Service Letter No. 412A (Supersedes No. 412)

SUBJECT: Muffler and Tailpipe Support

MODELS AFFECTED: PA-24 "250" Comanches only, Serial Nos. 24-2175, 24-2299 to 24-3321 incl., 24-3323 to 24-3394 incl., 24-3396 to 24-3437 incl., 24-3439 to 24-3441 incl., 24-3443, 24-3444, 24-3446 to 24-3457 incl., 24-3459, 24-3460, 24-3462 to 24-3464 incl., 24-3466 to 24-3484 incl., 24-3488 to 24-3536 incl., 24-3538 to 24-3549 incl., 24-3551 to 24-3557 incl.

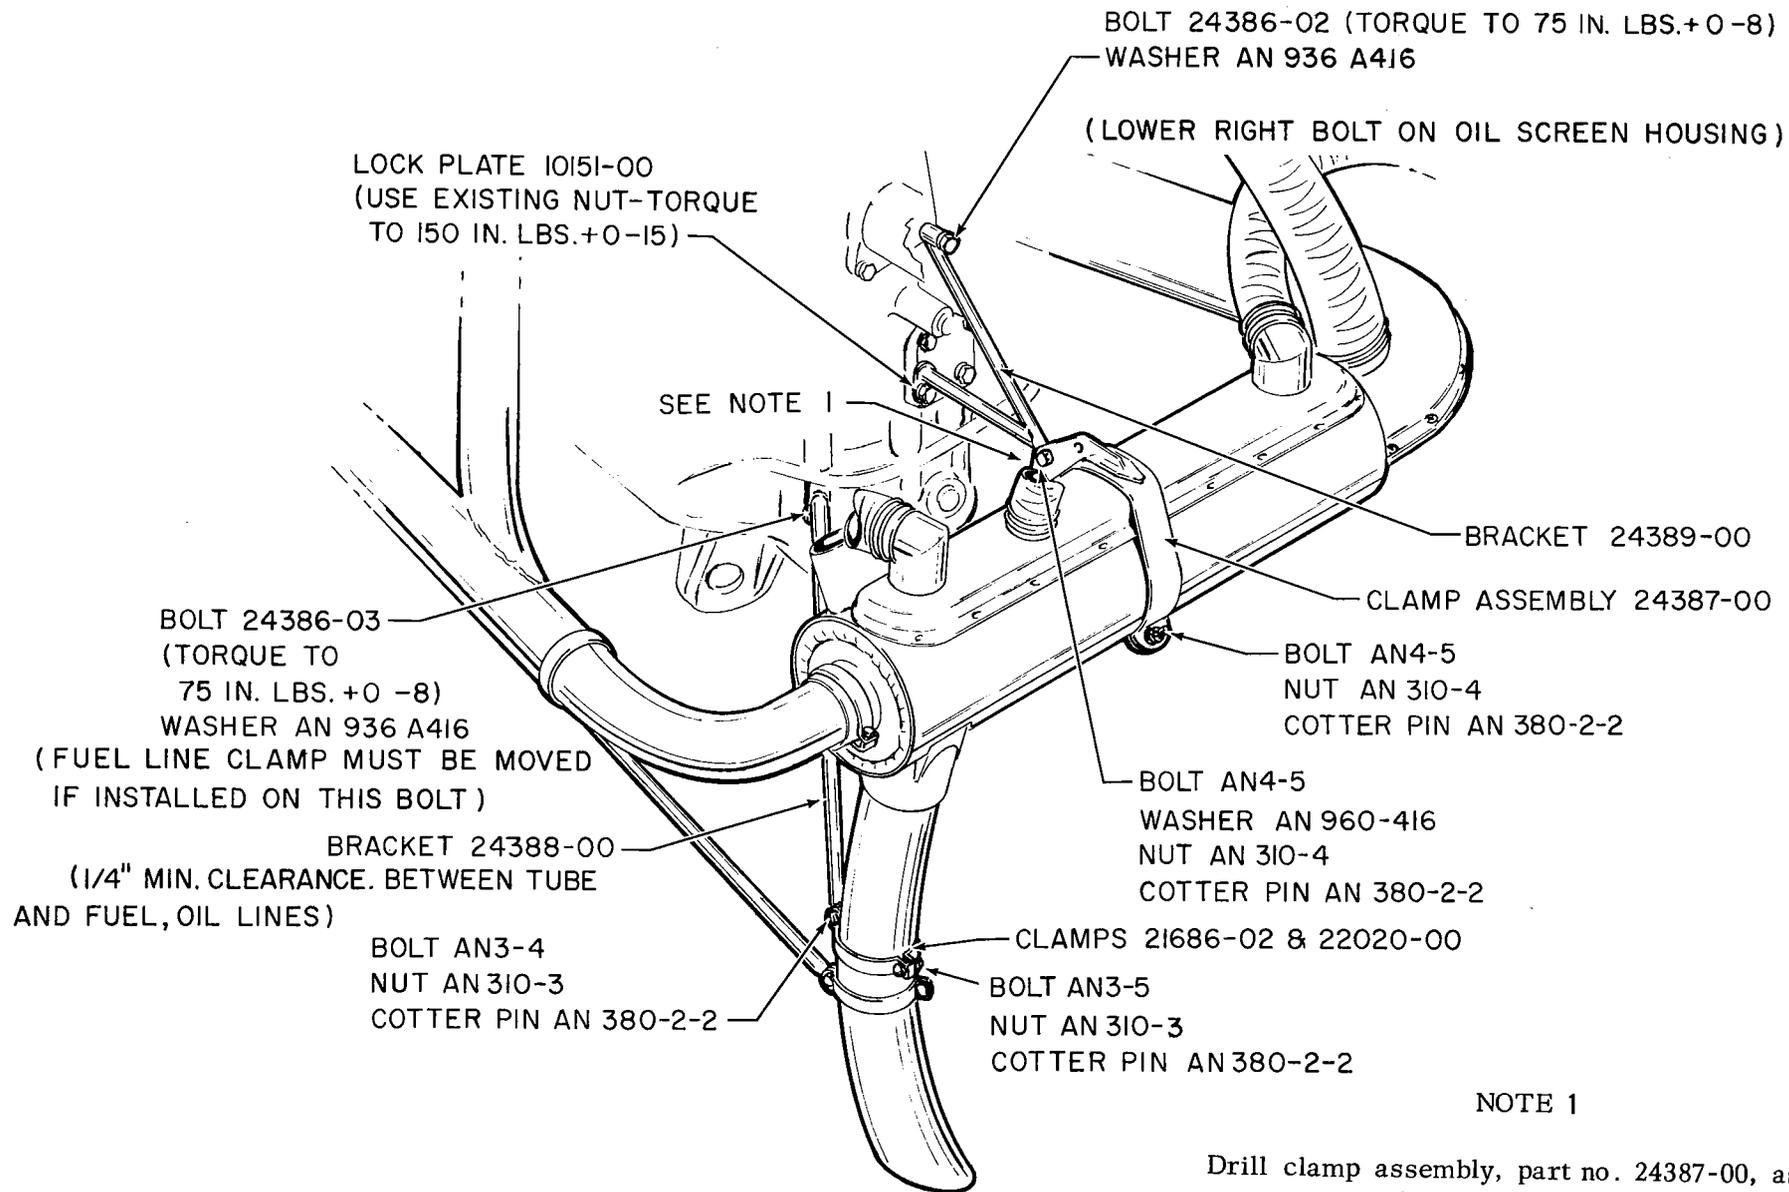
This Service Letter is to advise that a muffler support bracket and a bracket to support the tailpipe are available for installation on the subject aircraft.

These supports are applicable to the PA-24 "250" Comanches within the serial numbers listed above and it is recommended that they be installed on these aircraft as the additional support will be instrumental in extending the service life of the exhaust system.

NOTE 1

Drill clamp assembly, part no. 24387-00, as necessary to align with support bracket, part no. 24309-00. Disregard the two tooling holes in the clamp assembly. (Use .250 drill)
